# KINGSWOOD BATTERY ENERGY STORAGE SYSTEM

**Amendment Report**

April 2025

SSD-63207219

Figure 1-2: Overview of the amended Project envelope and footprint

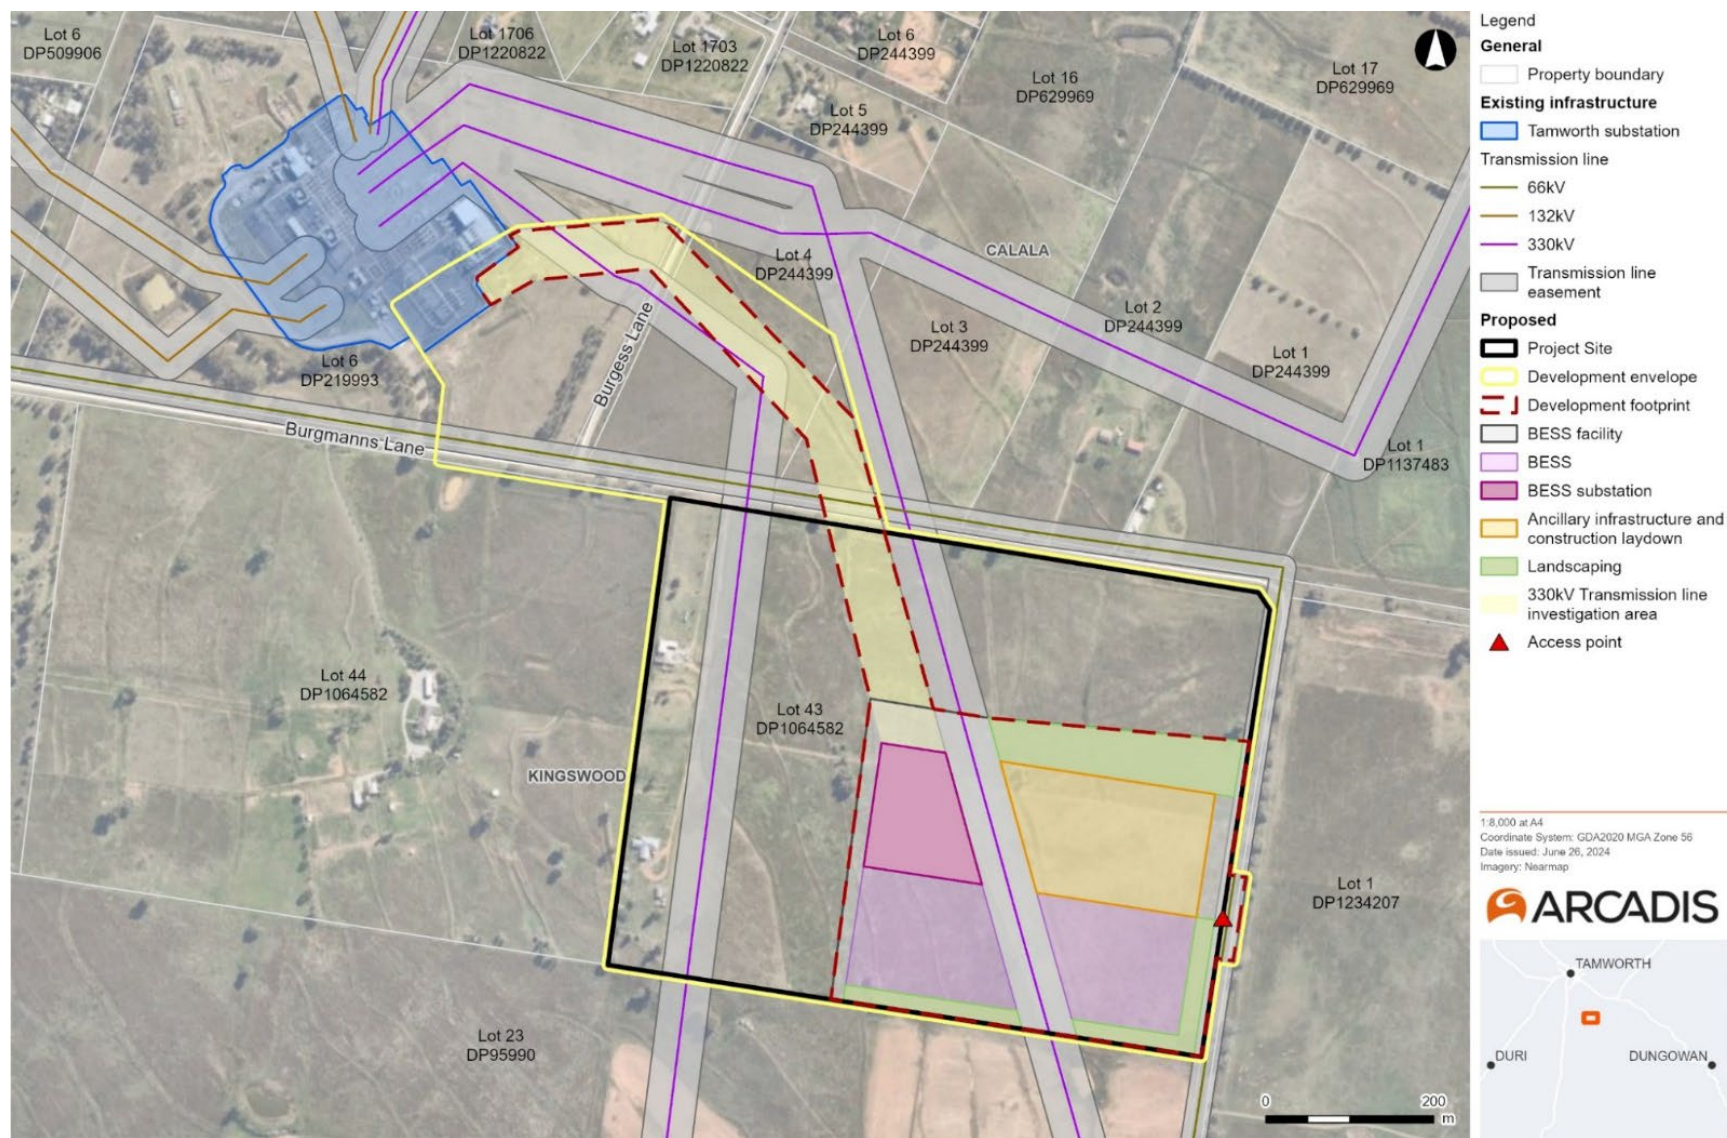
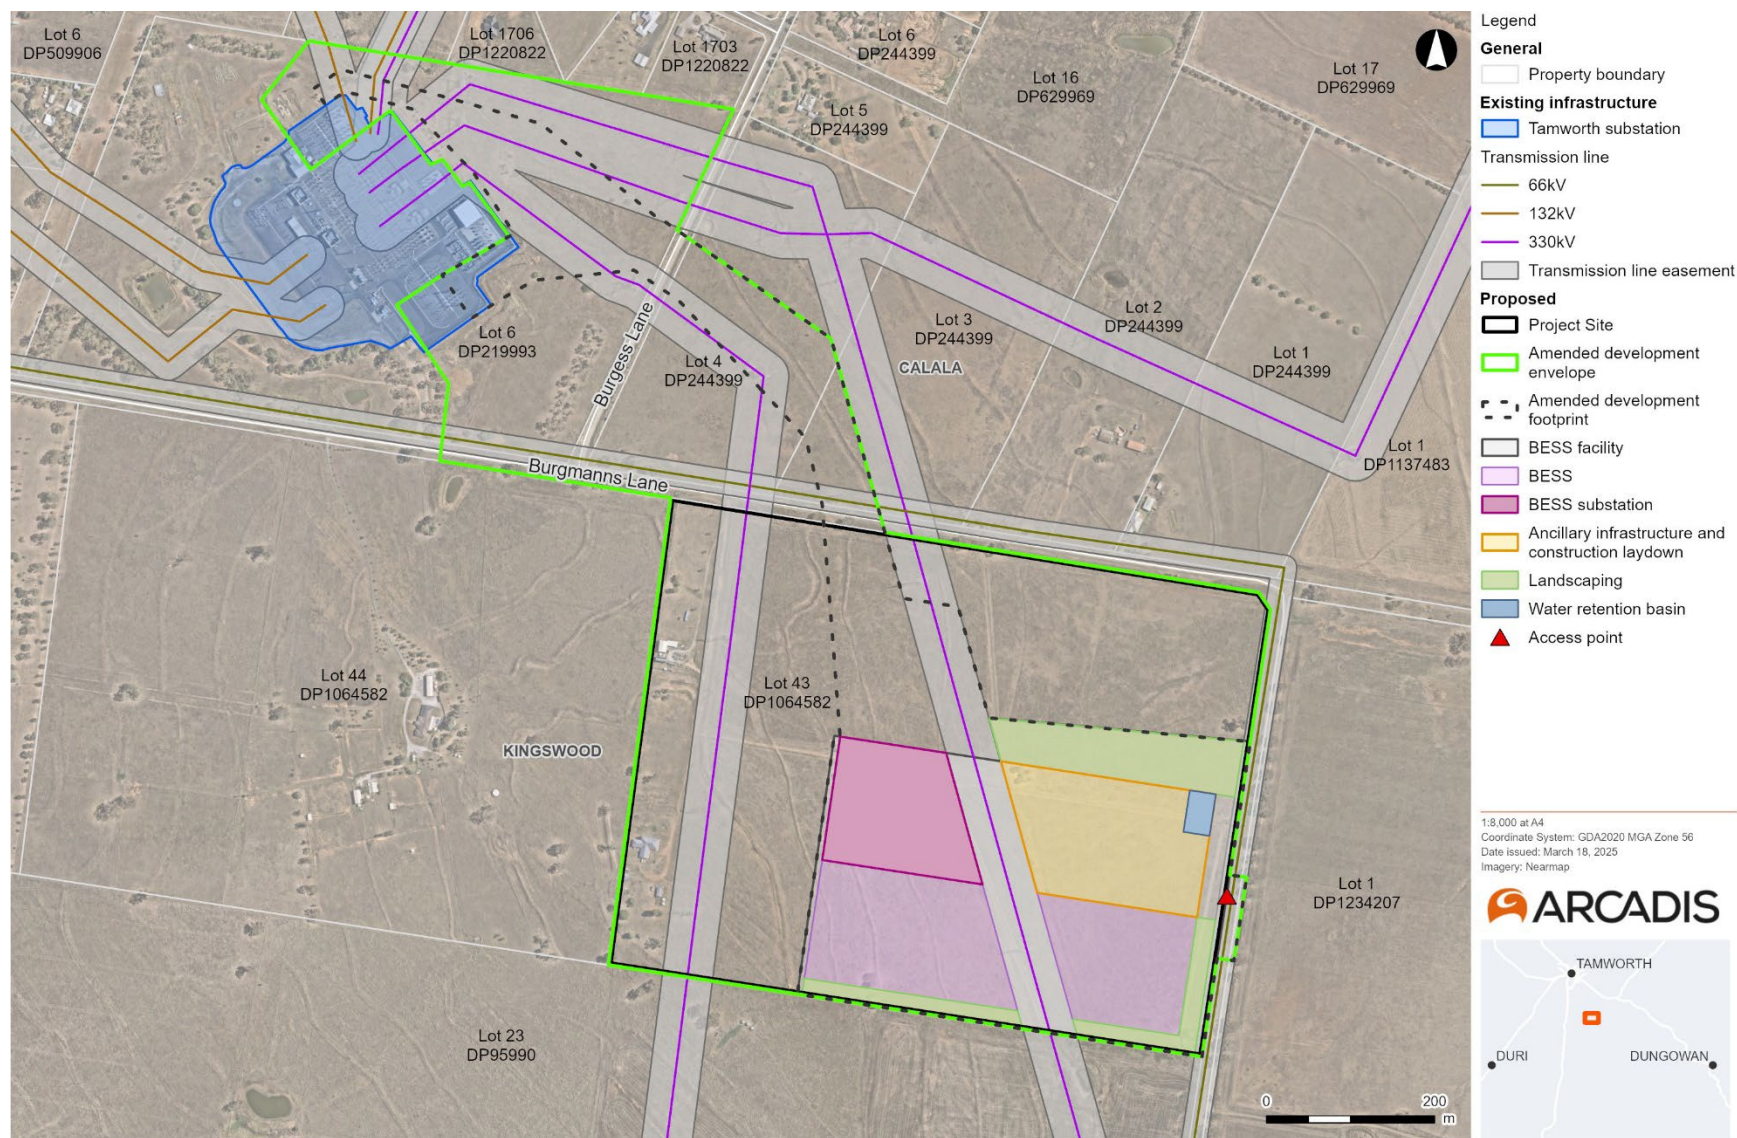
The additional connection solutions have also resulted in an amendment to the development envelope and footprint as shown in Figure 1-2.

The BESS would operate 24 hours a day, seven days a week and be monitored remotely, with infrastructure maintenance undertaken on-site. An overview of the amended Project is shown in Figure 1-2.

Figure 3-2 Solution 2- Underground cable northern bay alignment

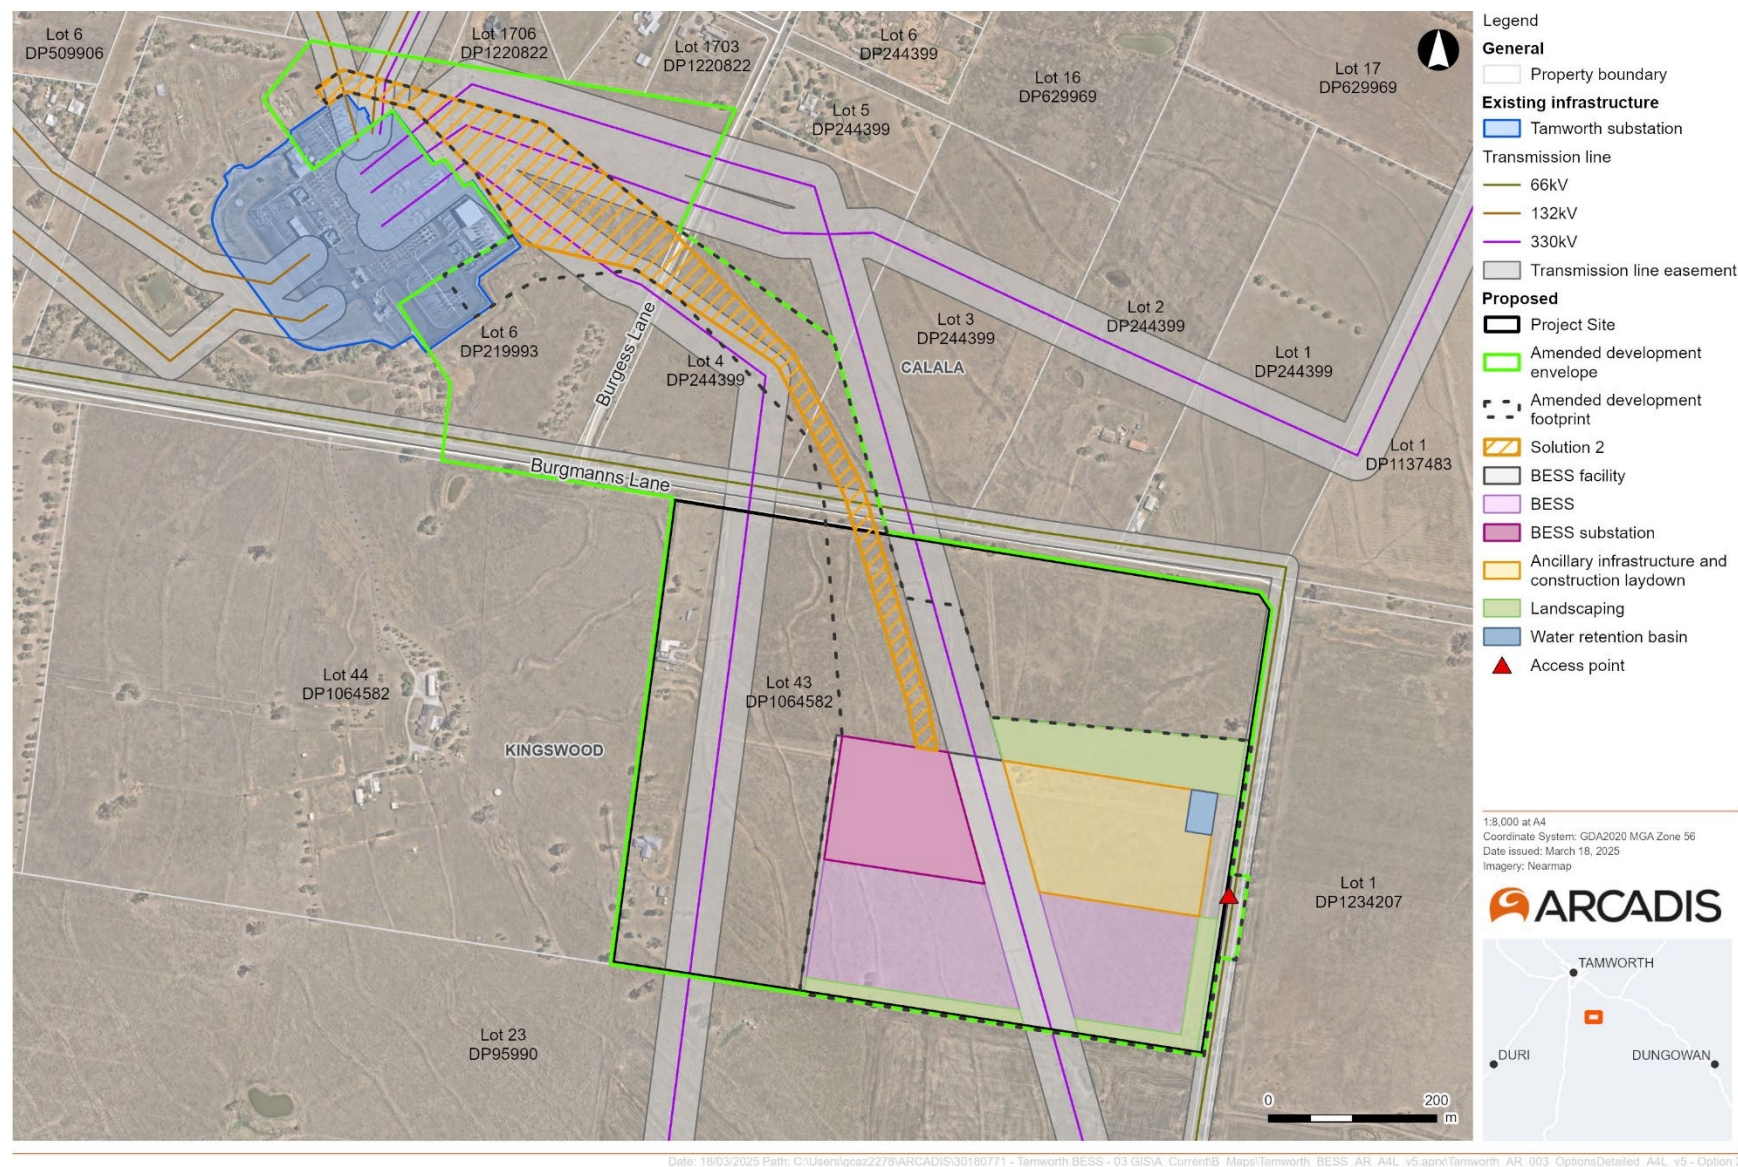
The underground cable northern bay alignment would be located within the amended development envelope (refer to Figure 3-2). The key elements of this connection include:

- A 330 kV underground transmission line of approximately 1,150 metres in length that would extend from the Kingswood BESS substation to the Tamworth substation
- The disturbance area for the connection would be in accordance with Transgrid requirements for 330 kV lines
- A section of the underground cable would be within the amended development envelope and would tie into the Tamworth substation from the north (refer to Figure 1-2)
- The trench would be about one to two metres wide and about 1.5 metres deep (with cables buried approximately one meter underground to the top of the cable)
- Once the trenching is complete, the surface above the cable would be returned to its pre-construction state
- The final alignment of the transmission connection is subject to consultation and agreement with Transgrid but would be located within the development envelope.

Solution 2 would extend the development envelope and footprint to the northwest and would be about 5.19 hectares (refer to Figure 3-2).

Figure 3-3 Solution 3 - Connection to existing overhead transmission line

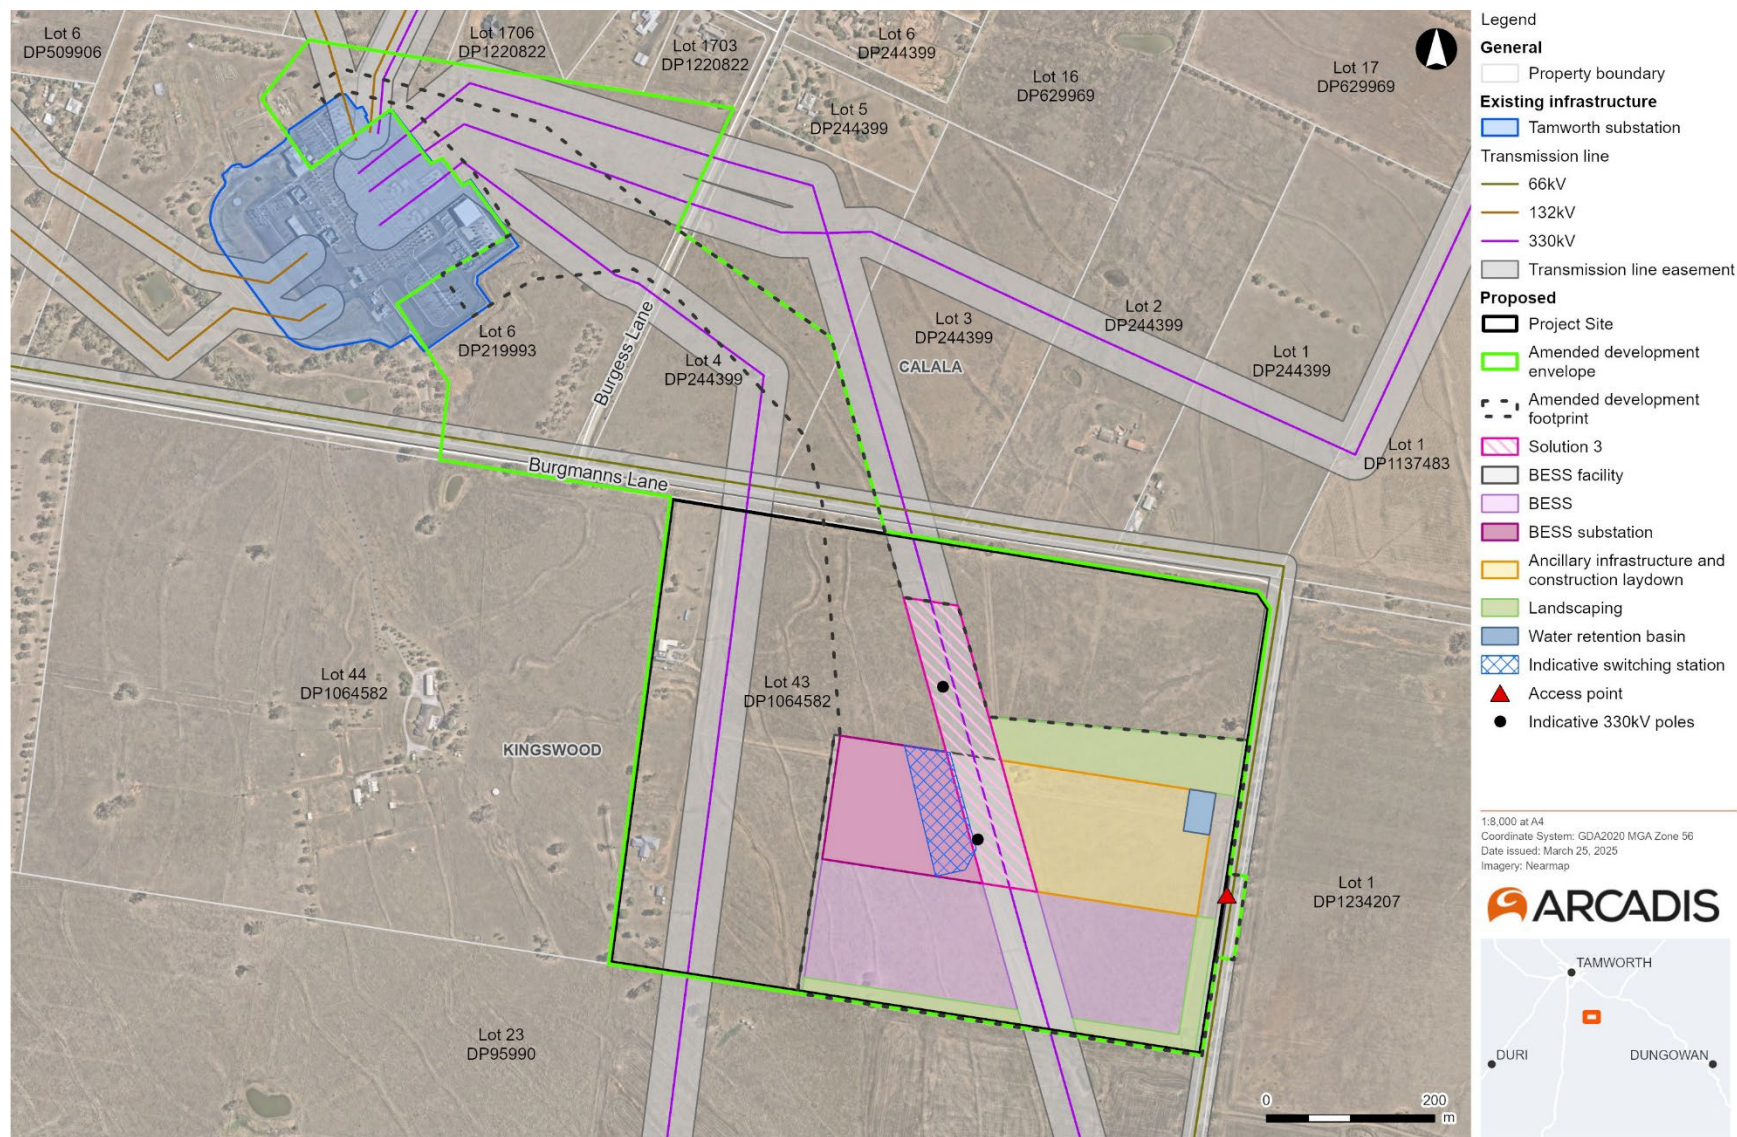
The proposed overhead connection to the existing transmission line would be located within the current development envelope (refer to Figure 3-3). The key elements of this connection include:

Solution 3 is within the existing development envelope but would slightly extend the development footprint to the west and would be about 2.12 hectares (refer to Figure 3-3).

Figure 3-4: Amendment to Project development envelope and development footprint and connection solutions

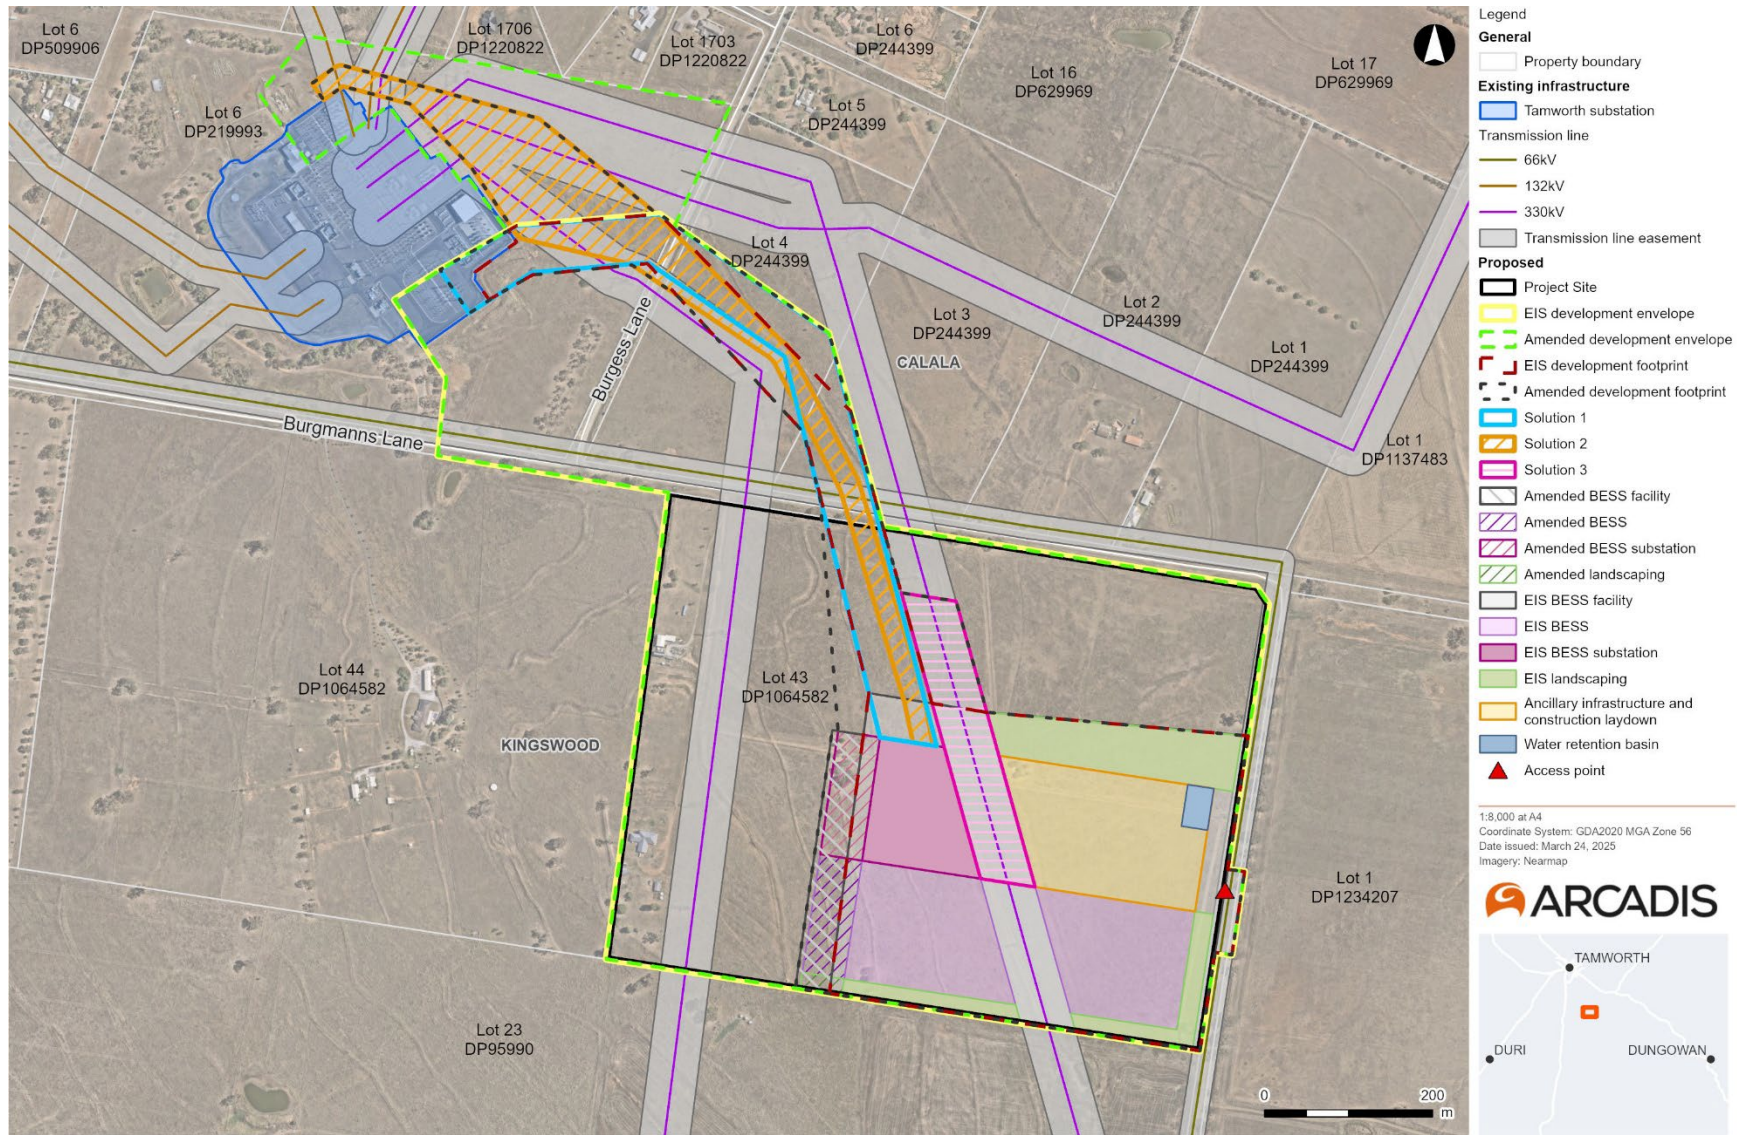
The additional connection solutions have resulted in an amendment to the development envelope and footprint as shown in Figure 3-4. The amended development envelope and footprint equate to 61.55 hectares and 27.95 hectares respectively. The amended development envelope and footprint also includes an increase to the BESS and BESS substation to allow sufficient space to co-locate the switching station with the BESS substation. The extension of the BESS and BESS substation footprint allows for a worst-case scenario for all Solutions and has been assessed by the technical specialists included in this Amendment Report.
